# NRC Advanced FEA Confirmatory Project

**U.S. NRC**  
UNITED STATES NUCLEAR REGULATORY COMMISSION  
*Protecting People and the Environment*

Al Csontos & Ted Sullivan  
August 9, 2007

# Advanced FEA Project: Phase I Results

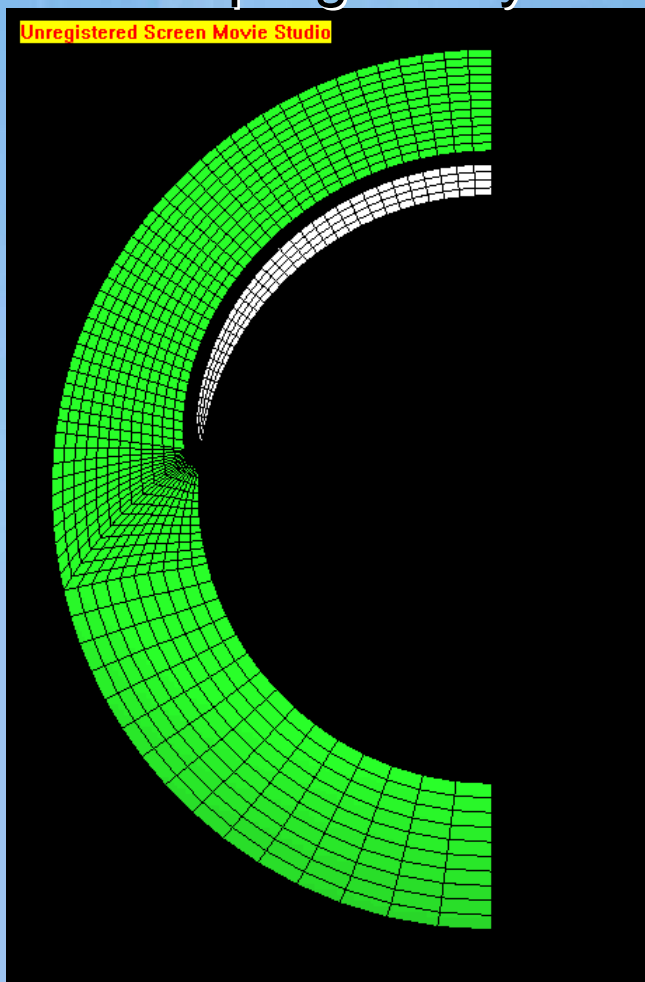
- Phase I Wolf Creek relief nozzle reevaluation:
  - 26% flaw depth
  - 21:1 c/a flaw ratio
  - ASME Section XI WRS
- Semi-elliptical assumption proved to be conservative for this ASME Section XI type flaw evaluation

Time to First Leakage (yrs)			
Scoping Study		Phase I	
NRC	MRP	NRC	MRP
1.9 - 2.6	4.4	5.40	5.36

Time Margin b/w Leak & Rupture (days)			
Scoping Study		Phase I	
NRC	MRP	NRC	MRP
-	-	105	152

Leak Rate (gpm)			
Scoping Study		Phase I	
NRC	MRP	NRC	MRP
Rupture	Rupture	0.4 - 6.9	0.38 - 7.9

## Advanced FEA Project: Phase II Result Summary

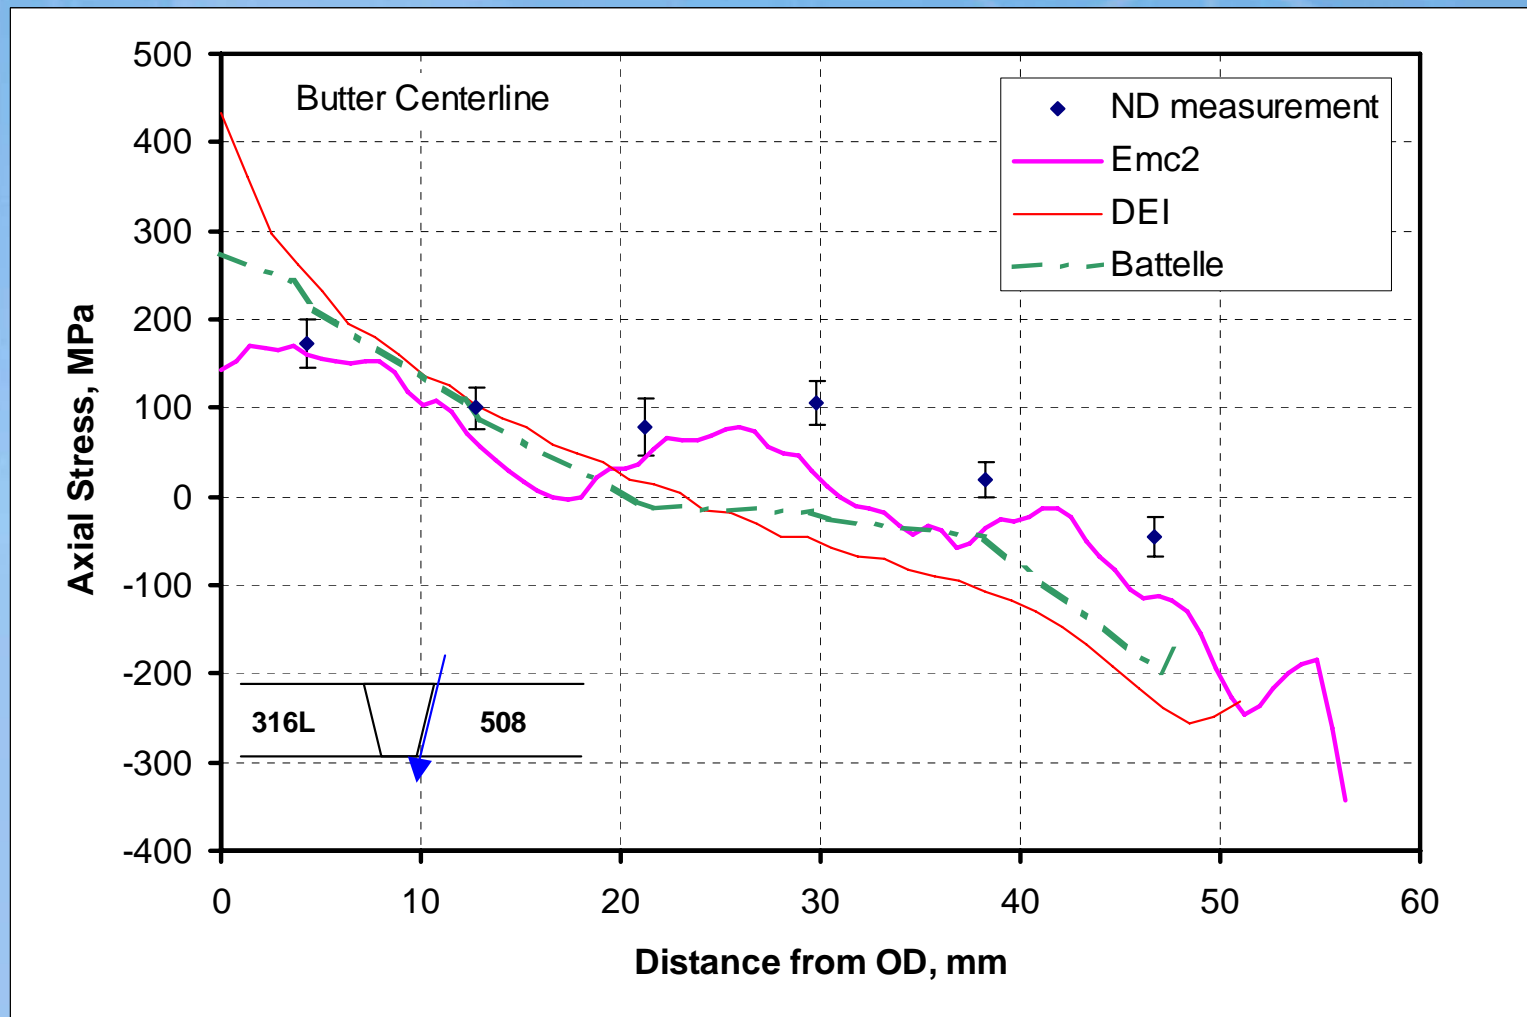
- Of the 30 cases in the NRC confirmatory program,
  - All 11 safety/relief cases showed either arrest or substantial margin between leakage and rupture
  - 3 out of 4 spray cases showed crack arrest with the final case predicting >50 years to leakage with substantial margins between leakage and rupture
  - 6 out of 15 surge line cases show little margin due to multiple conservatisms used in the analysis
  - 9 out of 15 surge line cases show either arrest or some margin between leakage and rupture

# Advanced FEA Project: WRS Validation

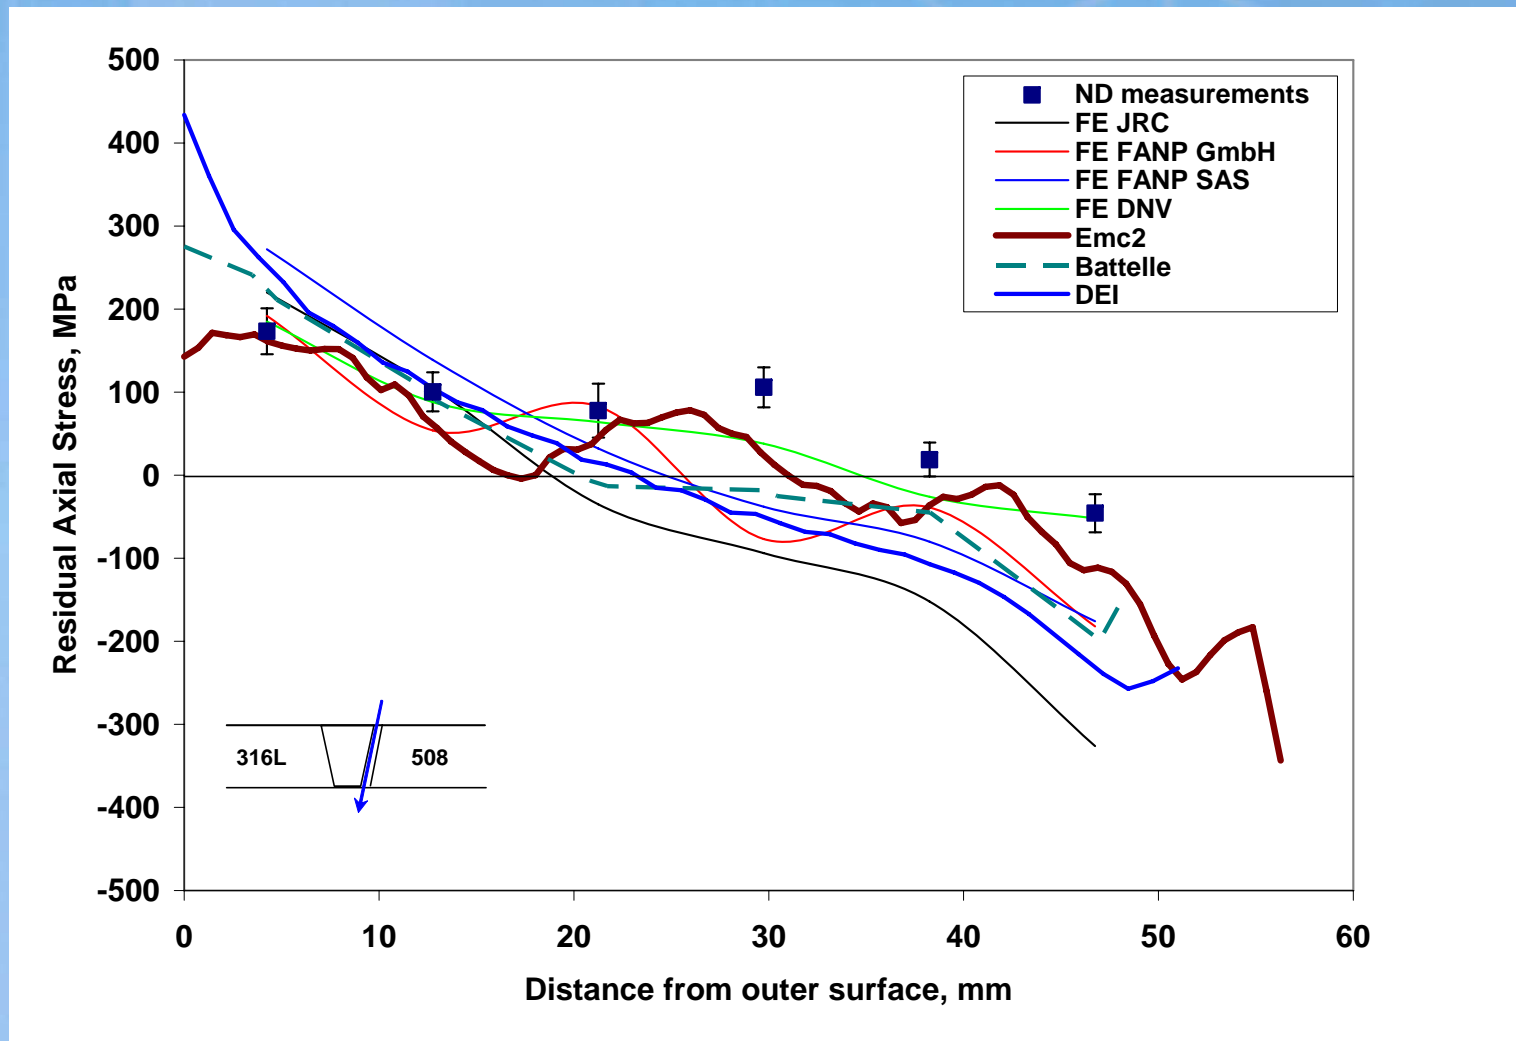
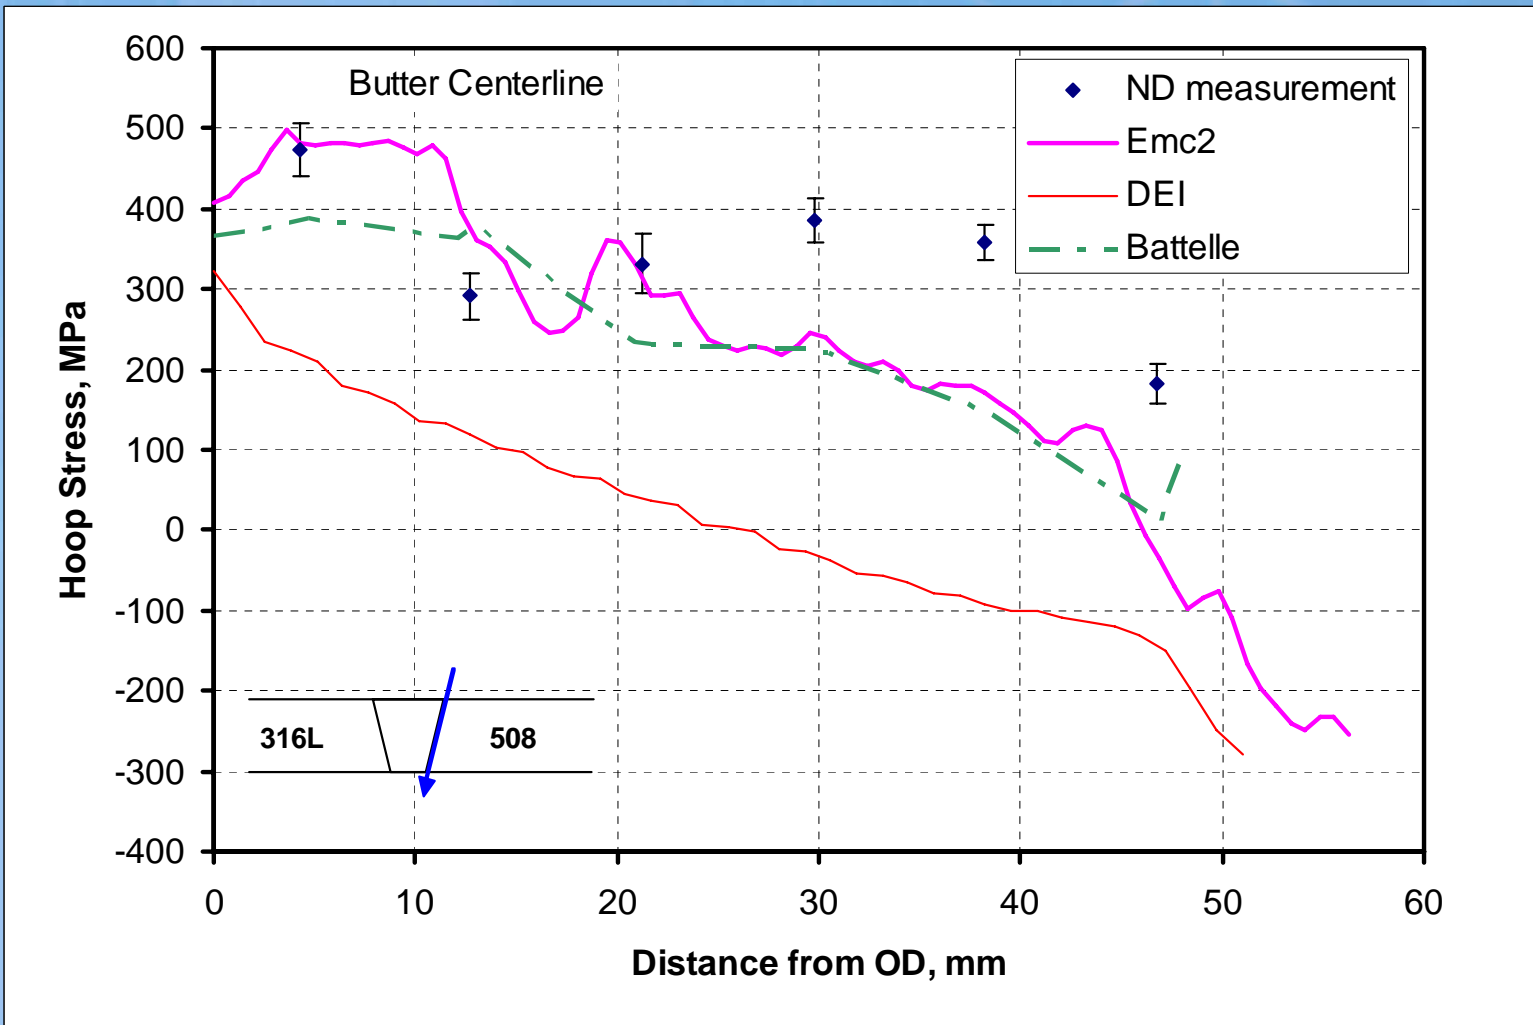
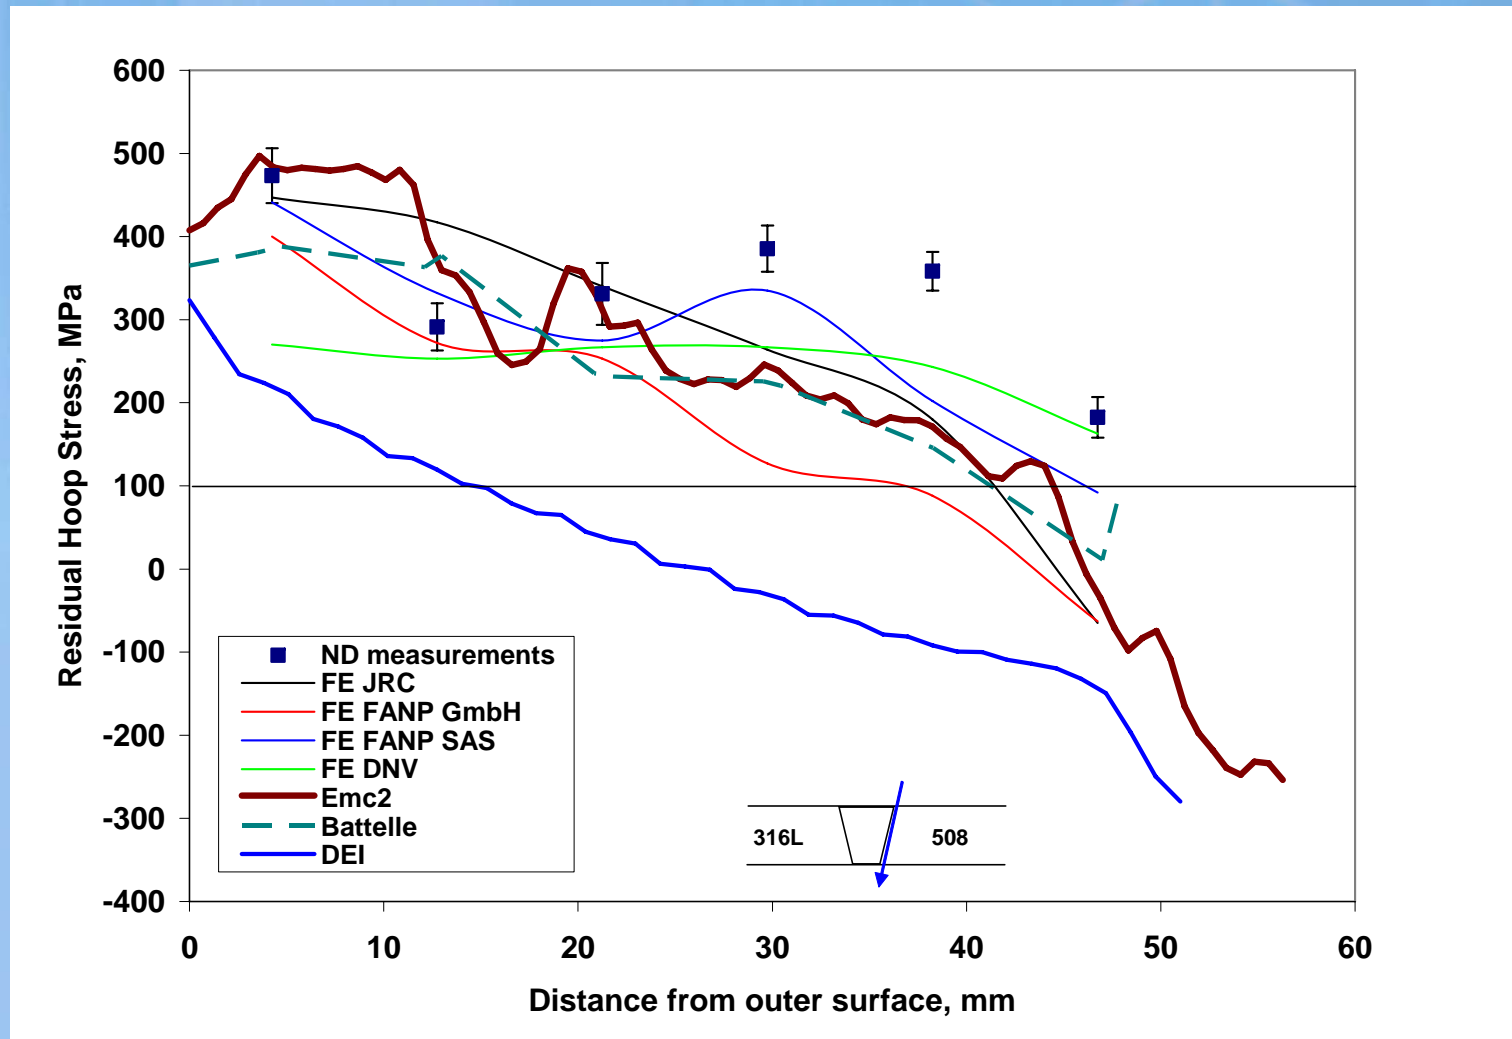
- Crack growth modeling in DM butt welds is highly dependent upon WRS distributions
- Changes in WRS profiles have a large effect on crack growth behavior, i.e. arrest or rupture predicted for certain surge line cases
- Therefore, WRS model validation undertaken
- Model results in good agreement for the butter centerline considering WRS model assumptions
